PLEASANT AVE., BEAKS ISL.

APPLICATION FOR PERMIT

To construct 1-story frame addition 14'x26' to rear and side of dwelling.
To cut in one new door in place of window

AP Pleasant Ave., Peaks Island (88-I-19)

John Hambelton
Pleasant Ave.
Peaks In, Me.

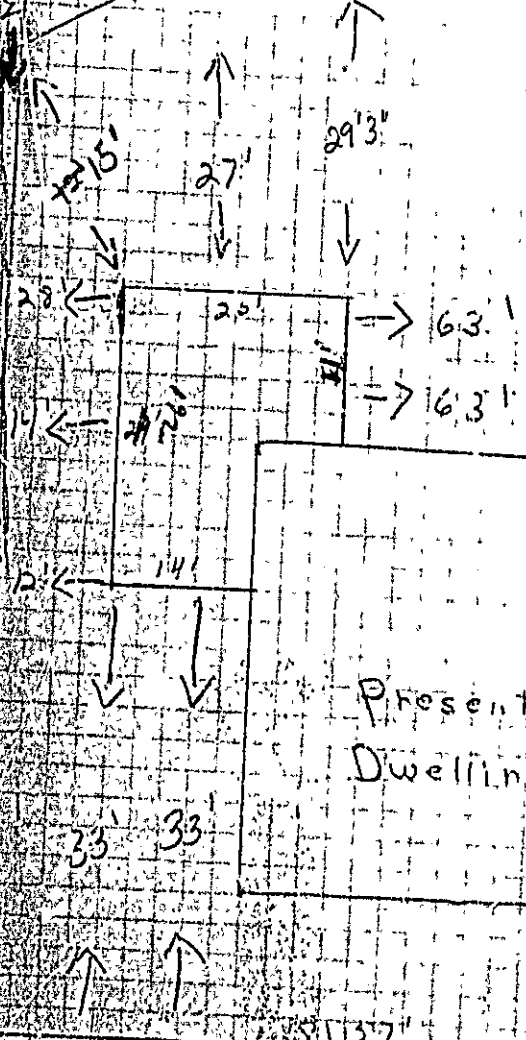
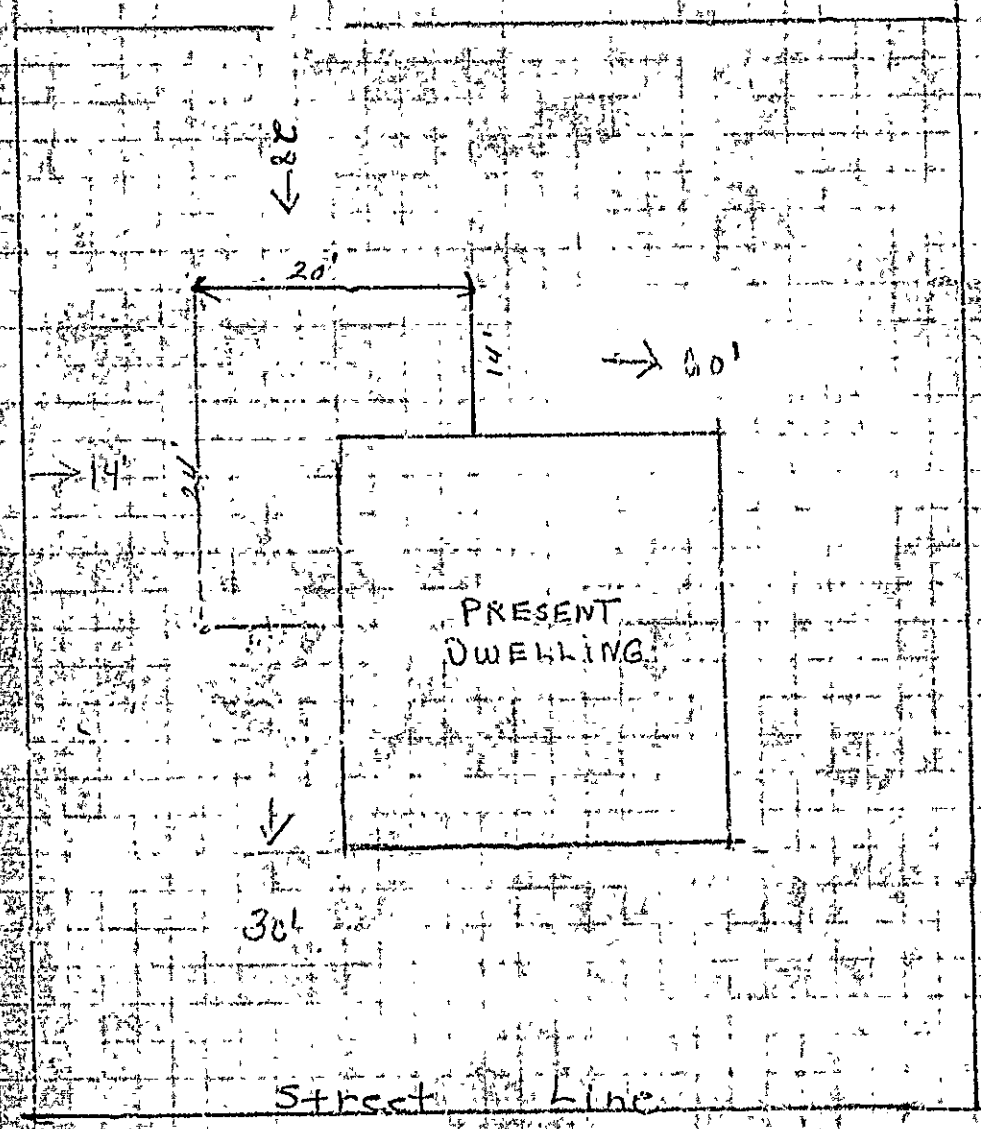
On the basis of the plot plan which you have furnished and inspection of the premises indicates that one corner of the addition which you propose to erect on the rear of your dwelling at the above named location will extend to within about 12 feet of the rear lot line. This property is located in an R-3 Residential Zone where a minimum rear yard depth of 15 feet is required by Section 19-P of the Zoning Ordinance. Thus unless a clearance from the rear lot line of not less than 15 feet is to be maintained, I am unable to issue a permit for construction of the addition. If it is not possible or feasible to maintain such a clearance, you have the right to ask the Board of Appeals for relief from compliance with the precise terms of the Ordinance in this particular instance. If you are interested in doing so, I shall be glad to explain the appeal procedure upon request.

In checking your application for a permit for constructing an addition on the side and rear of your dwelling at the above named location, we find that according to Assessors' records the lot on which the building is located is apparently peculiarly shaped and much different than indicated on the plot plan which you have furnished. For this reason we are unable to determine whether or not clearances from lot lines as required by the Zoning Ordinance are to be maintained for the addition.

It is therefore necessary that you furnish us with an accurate plot plan of the lot with the building shown thereon as it is located on the lot and the actual distances shown from the addition to street and lot lines. It is also necessary that the corners of your lot be clearly marked on the ground and that the corners of the addition be staked out so that an inspector from this department can check the location on the ground. Until this has been done we are unable to proceed further with processing of your application.

1. Rear corner of addition is to be no closer than 15 feet to rear lot line.
2. Concrete piers are to be 8 inches square and are to extend at least 4 feet below grade or to ledge and at least 6 inches above the surface of the ground.
3. All sills and the girder are to be 6x3 timbers with all splices located directly over one of the supporting piers. These members are to be anchored to the piers by metal pins or dowels set into the tops of the piers when poured.
4. Studs in walls are to extend down to the tops of the sills and not supported on shoes on top of the floor timbers.
5. Concrete piers are to be located about five feet on centers under the outside walls and at the center of the span of the girder.
6. Notification is to be given this department for inspection before any lath or wall board is applied to walls, partitions or ceilings.
